We Are The Voice of Our Rivers

**Regarding Proposed Outline Plan – Alpine Park
LOC2017-0378; CPC2020-0786; Bylaw127D2020**

Types of LID permeable pavers to manage stormwater

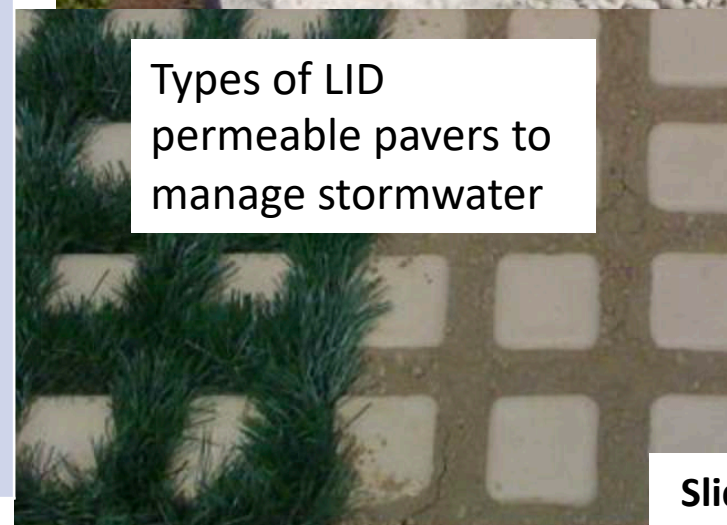
Category of Concern	Suggested Actions
Surface Water / Stormwater	<p>Outline Plan should incorporate recommendations made in the Master Drainage Plan & in the Urban Systems 3rd Party Review:</p> <ol style="list-style-type: none">1) “Oversize” the stormwater infrastructure to accommodate flows from future development to the west / climate change impacts, & reduce the damaging “fire hose” & sustained higher flow effects of stormwater entering into Fish Creek2) Use Low Impact Development (LID) strategies for managing stormwater onsite, especially with up to 70% of area allowed to be impervious, much higher than normal

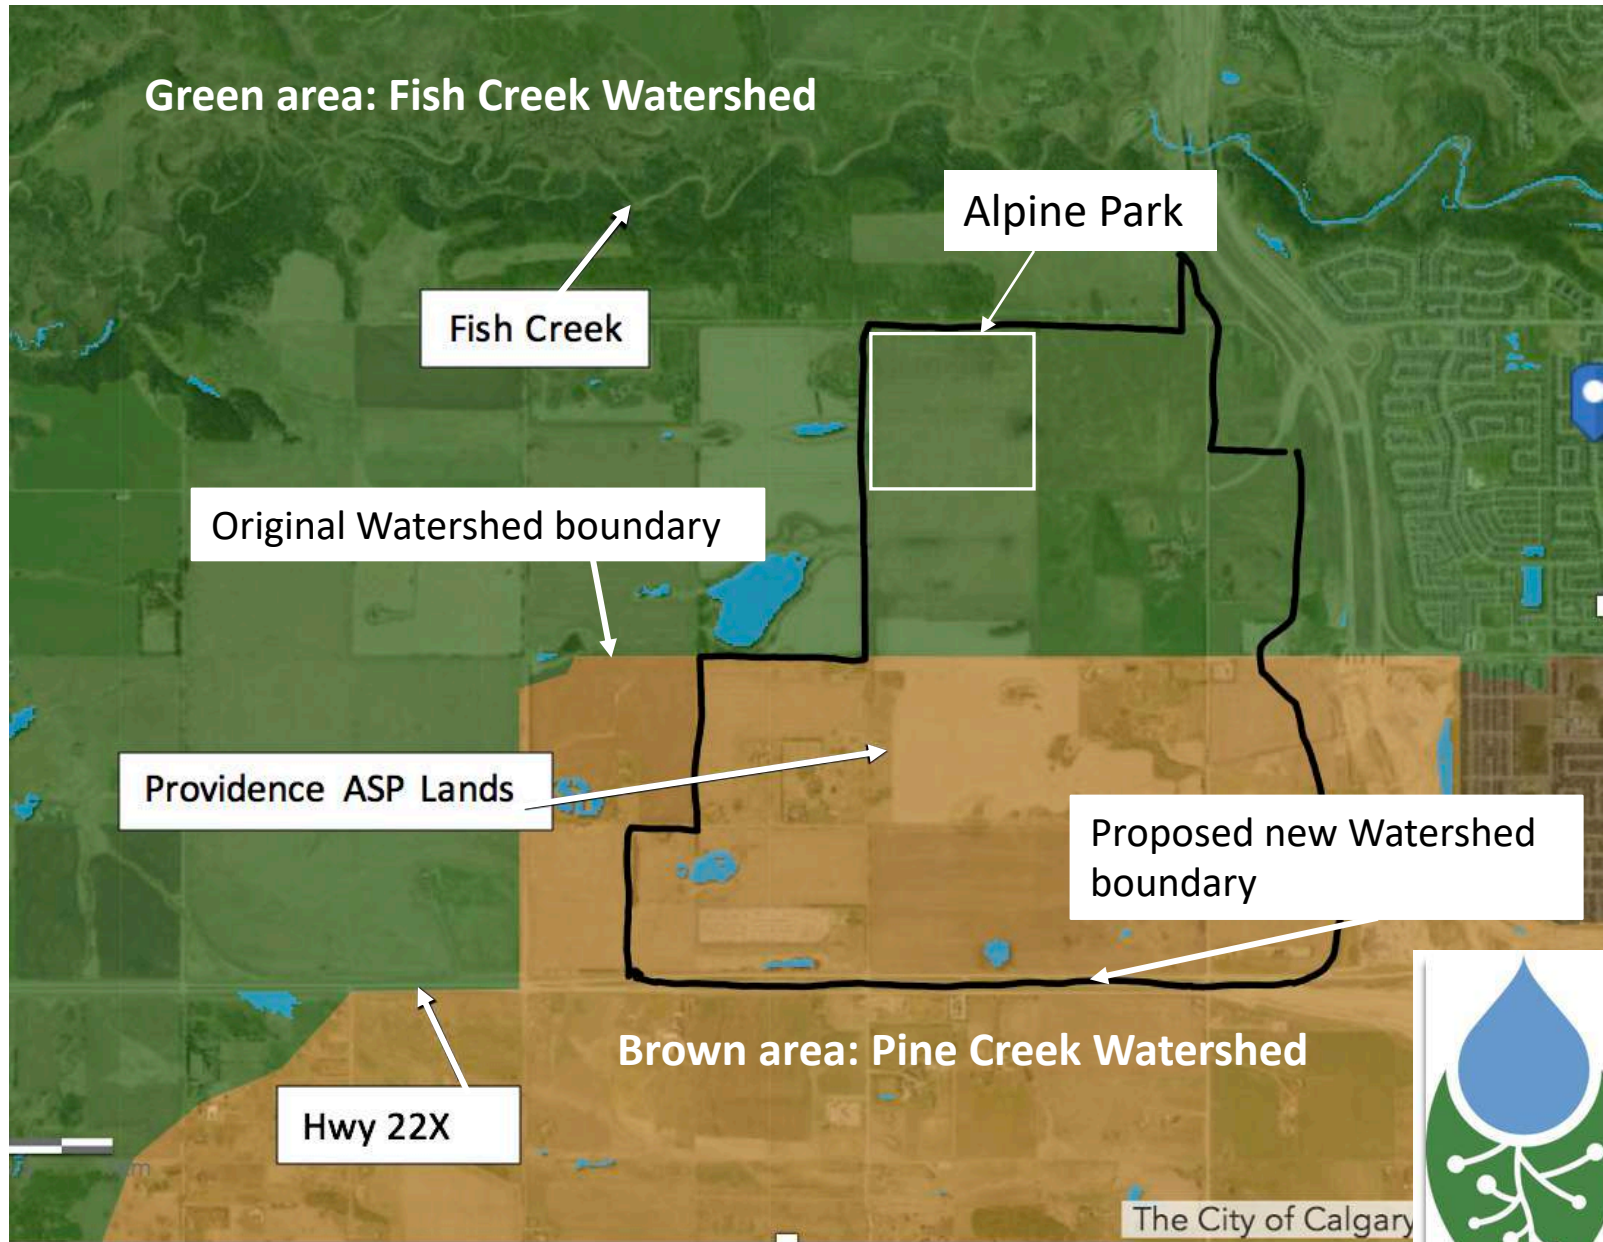
Category of Concern	Suggested Action
Re-Drawing Watershed Boundaries -- Fish Creek & Pine Creek	Detailed study required of anticipated impacts on Fish Creek & Pine Creek → diverting all surface water from the ASP lands into Fish Creek instead of approx. half to Pine Creek

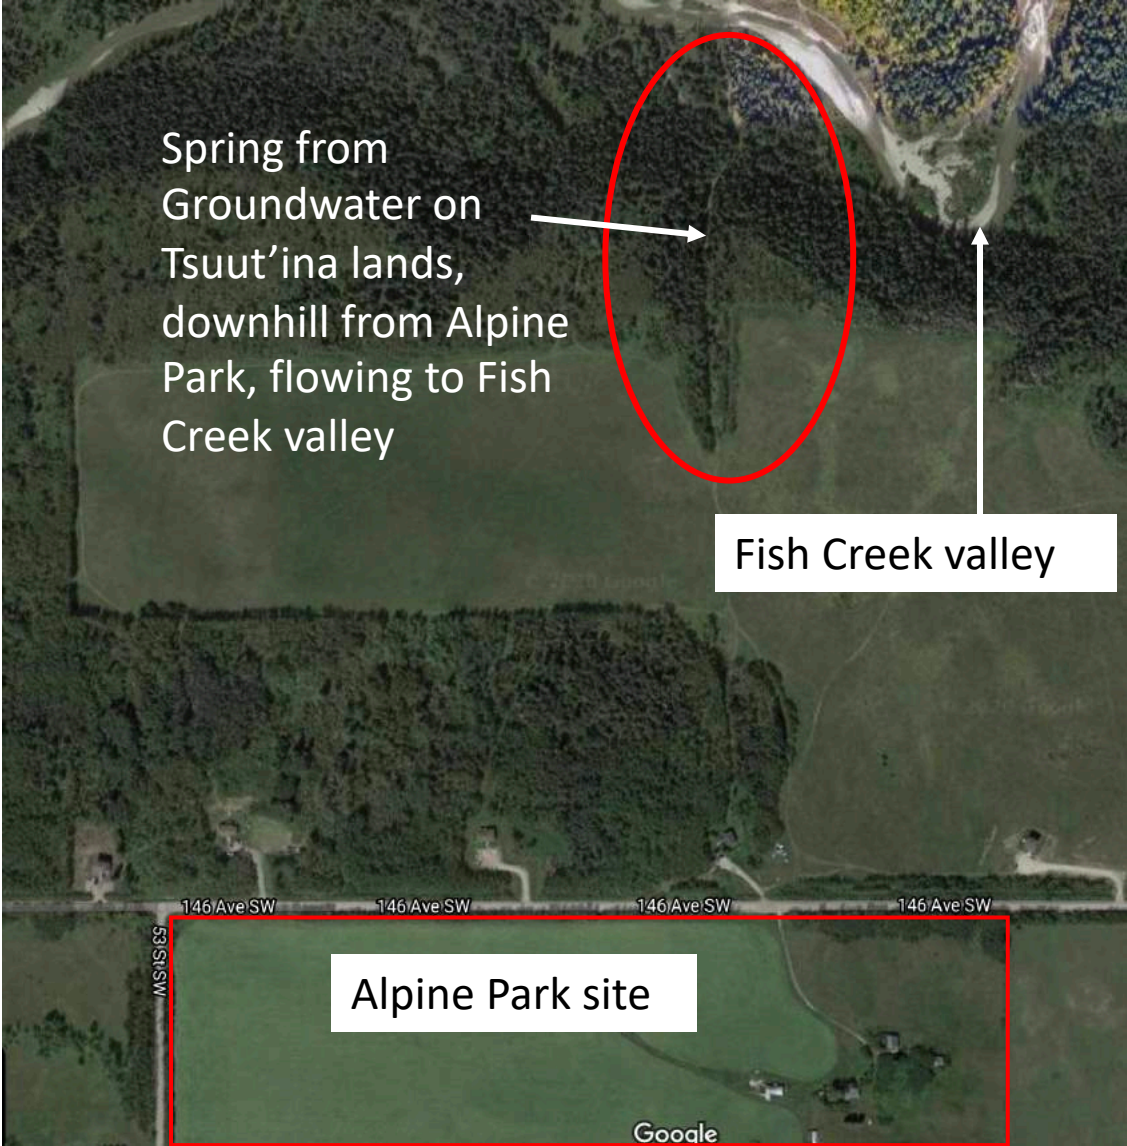
Category of Concern	Suggested Action
Sub-surface Groundwater	<ul style="list-style-type: none"> - Ensure pre-development groundwater flows downhill from Alpine Park to the Fish Creek valley, including Tsuut'ina lands are maintained - Complete and publish study of impacts of proposed changes to groundwater regime in area
